MILITARY SPECIFICATION

TRANSISTOR, PNP, GERMANIUM
TYPES 2N499 AND 2N499A

This amendment forms a part of Military Specification MIL-S-19500/72C(EL) 1/, dated 2 August 1967, and is approved for use by Army Electronics Research and Development Command, Department of the Army and is available for use by all Departments and Agencies of the Department of Defense.

FIGURE 1. Physical dimensions.

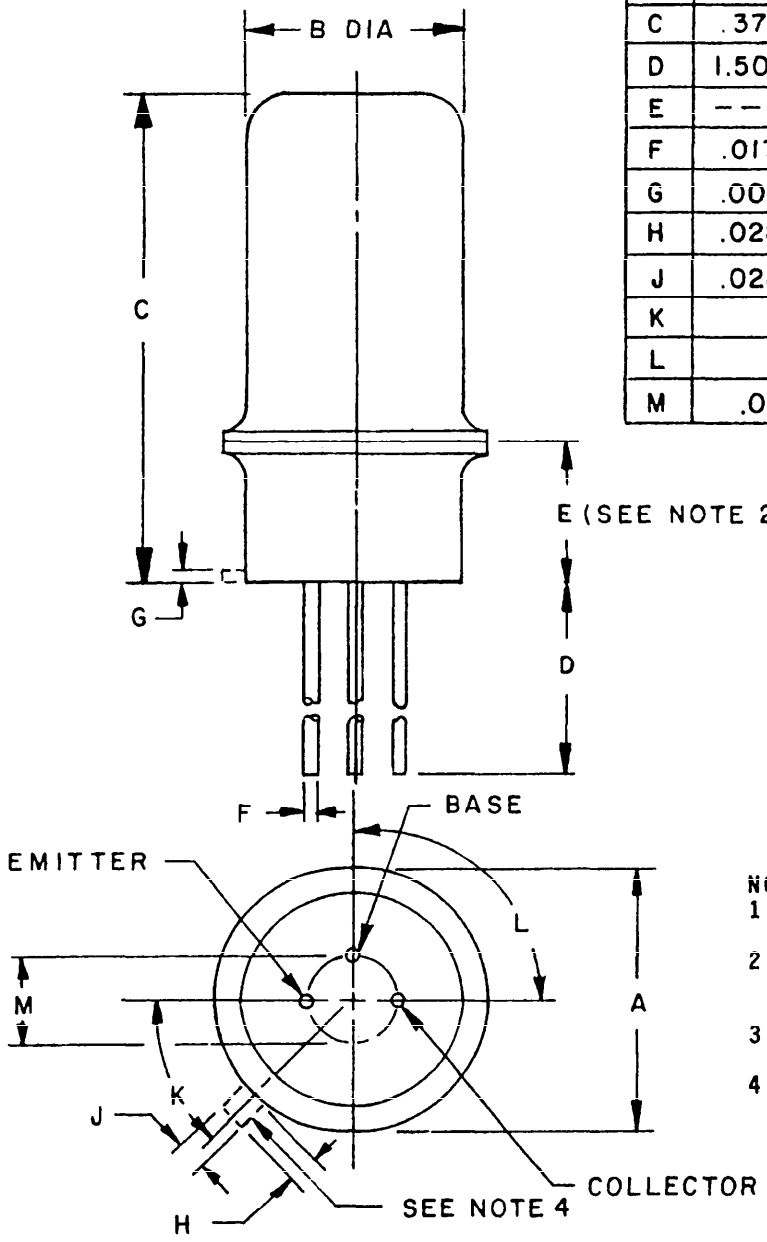
FIGURE 1: Delete and substitute new figure 1 as printed on page 3 of this amendment.
